March 1, 2019

**FROM:** Jillian Dierks, Planner, Building and Planning Department

**SUBJECT:** PRELIMINARY LAND DEVELOPMENT & CONDITIONAL USE PLAN – 9 & 11 Elliott Avenue & 762 W. Lancaster Avenue, Aqua Pennsylvania, LD# 3802, Ward 4

## Changes to the Plan

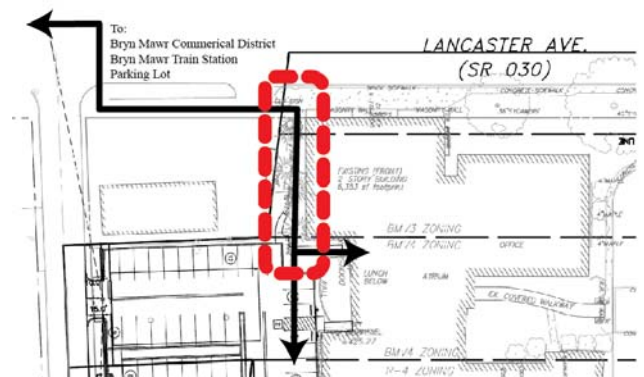
- The striping of the existing surface parking areas was reconfigured which result in the creation of two additional parking spaces to meet the parking requirement for the proposed development.
- An urban garden, complying with the regulations of the Subdivision and Land Development Code Section 135-41.4.D, has been provided along Elliot Avenue where the face of the building steps back from the build to line.
- The design of the previously identified ‘possible rain garden’ has been changed so that this area will function as a biofiltration area.
